Appendix I of RNTPC
Paper No. A/SK-HC/360A

**APPLICATION FOR PERMISSION
UNDER SECTION 16 OF
THE TOWN PLANNING ORDINANCE
(CAP. 131)**

TITLE :LV CABLE LAYING, POLE & STAY ERECTION AT HING KENG SHEK NEAR HOUSE NO.58A SAI KUNG	
MAP NO : 07SE25A, 07SE25B	
PROJECT REF.: SK2022-0692	PLAN REF.:WESK2022-0692-01H

寄件者: [REDACTED]
寄件日期: 2024年11月25日星期一 18:25
收件者: tpbpd/PLAND
主旨: Fw: Clarifications requested - CLP project ref. SK2022-0692, Hing Keng Shek
(Planning Application No. A/SK-HC/360)

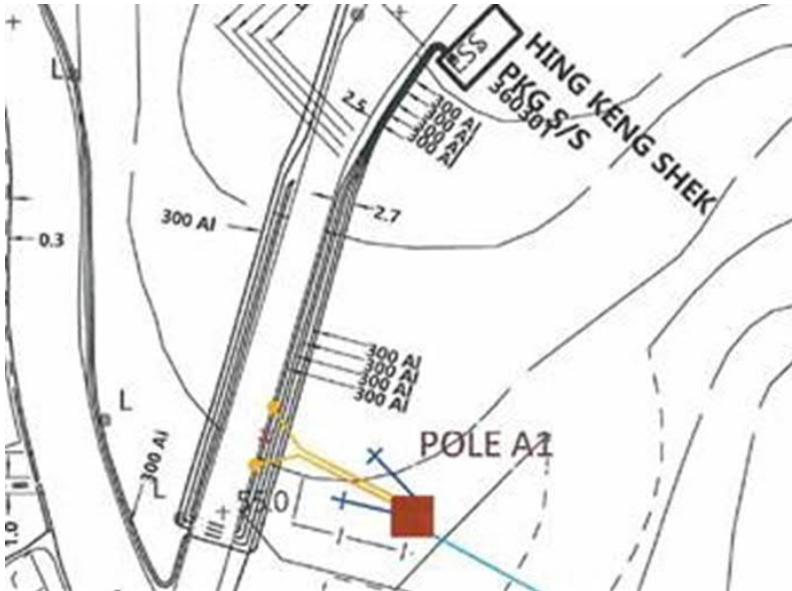
6. Please clarify the electricity supply routing to existing power network and whether the alignment connecting to the ESS are existing cables.

According to the drawing below. The black line represents the existing undergrounding power cable. The proposed work is

- a) Trench excavation to lay new underground cables (yellow line)
- b) Carry on the underground cable jointing (yellow spot)
- c) Backfill after upon completion of the installation works.

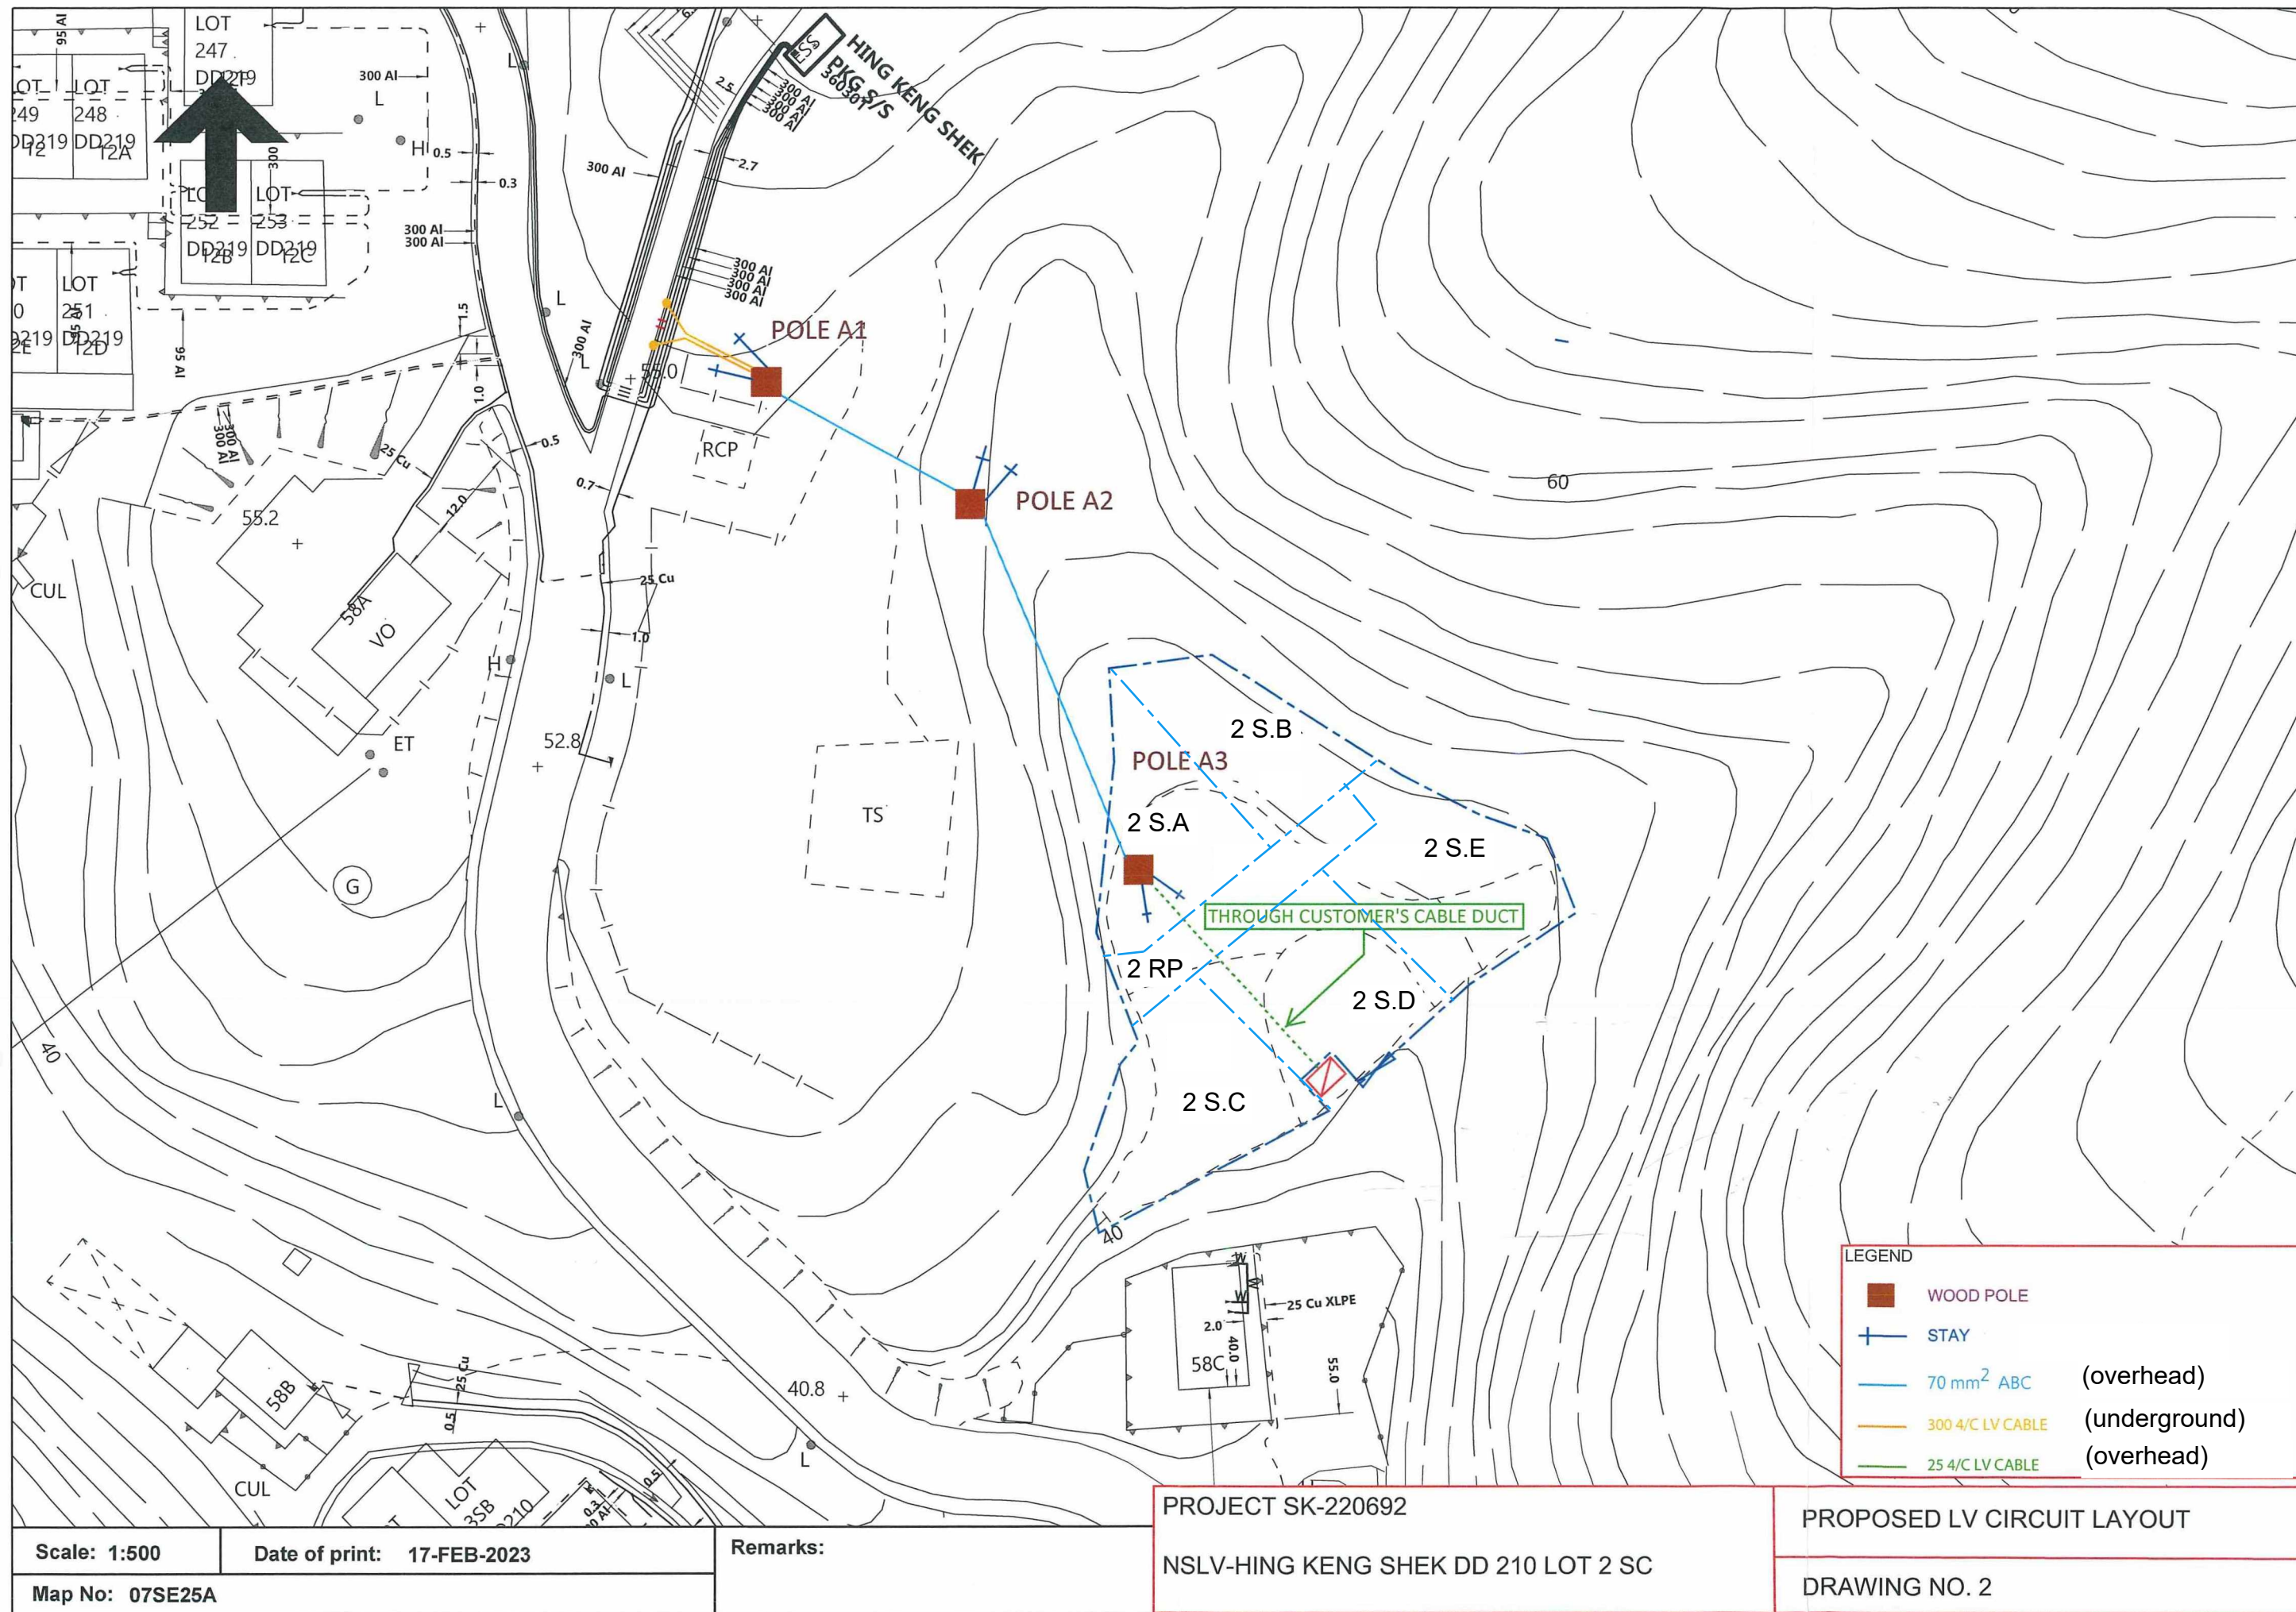
Please clarify and update the drawing:

- (1) The indication of lot number on the drawing below is inaccurate. Please rectify the lot numbers (from “DD210 Lot 2 SC” to “Lot 2 S.A., S.B., S.C, S.D, S.E and RP in DD210” on the drawing as appropriate.
- (2) The “customer’s cable duct” and the meter box illustrated below are not included in the planning application boundary submitted by CLP. Please clarify.

- (1)The update cable drawing with lot numbers are attached
- (2)The “customer’s cable duct” and the meter box illustrated are not included in this planning application.
